## Compressor Discharge Line LEU, MRU

### FSB 561-024, Compressor Discharge Line

(February 2014)

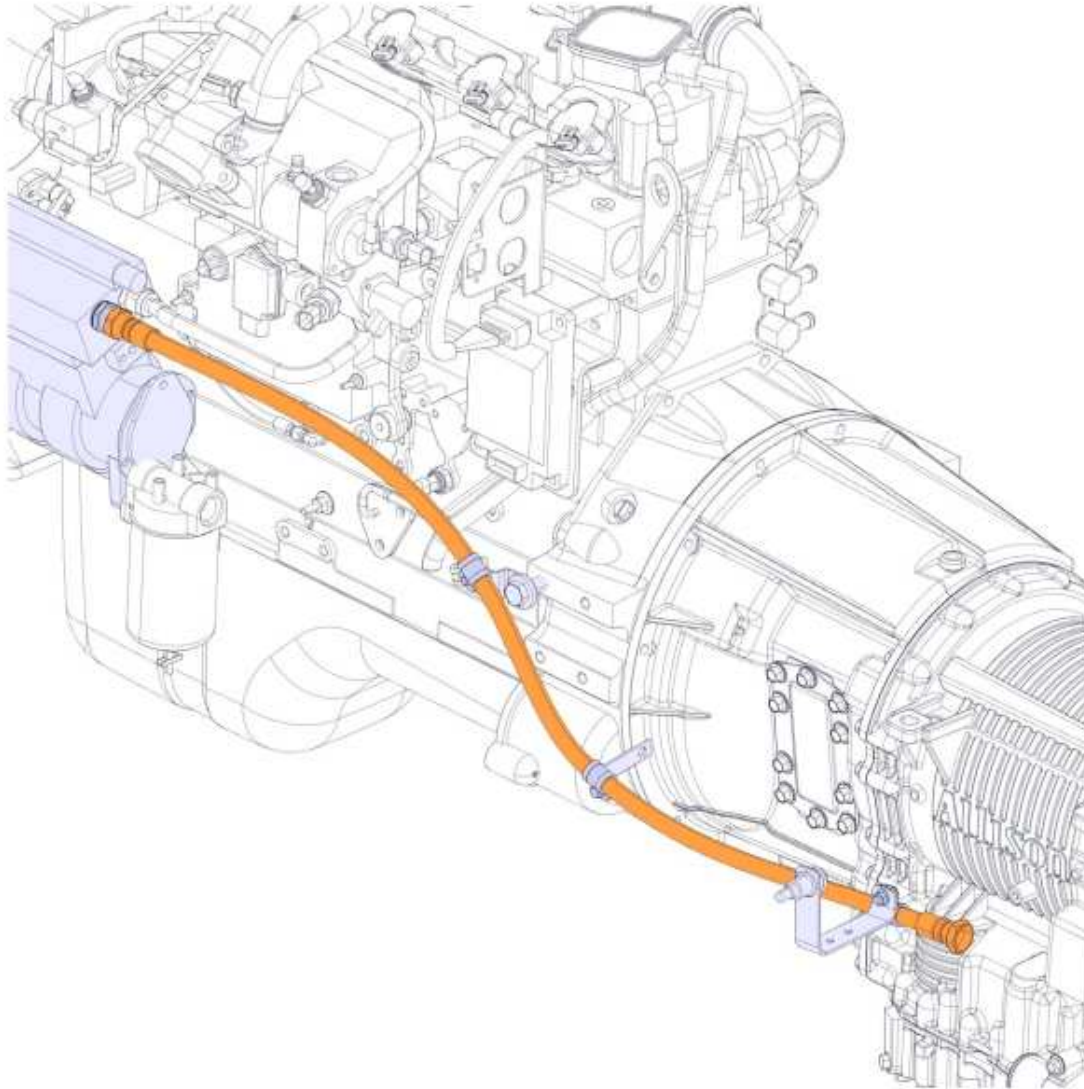
On LEU633 and MRU633 models built between March 2012 and August 2013 the brass collar that is crimped onto the stainless steel compressor discharge line may split, resulting in the inability of the unit to build air pressure. The original part numbers of the Stainless Steel line assembly that are affected are: 25195537, 25192424, and 21628882. Should a failure occur the discharge line should be replaced with the new compressor discharge lines that have a steel collar.

Original Part Number	New Part Number
25195537	22294501
25192424	22294478
21628882	22294531

- 1 Raise the cab.
- 2 Remove clamps securing main air line.
- 3 Disconnect braided line.
- 4 Install the replacement braided line. Tighten securely.
- 5 Install clamps securing main air line.
- 6 Start engine. Build air to maximum pressure and check for leaks.
- 7 Lower cab.
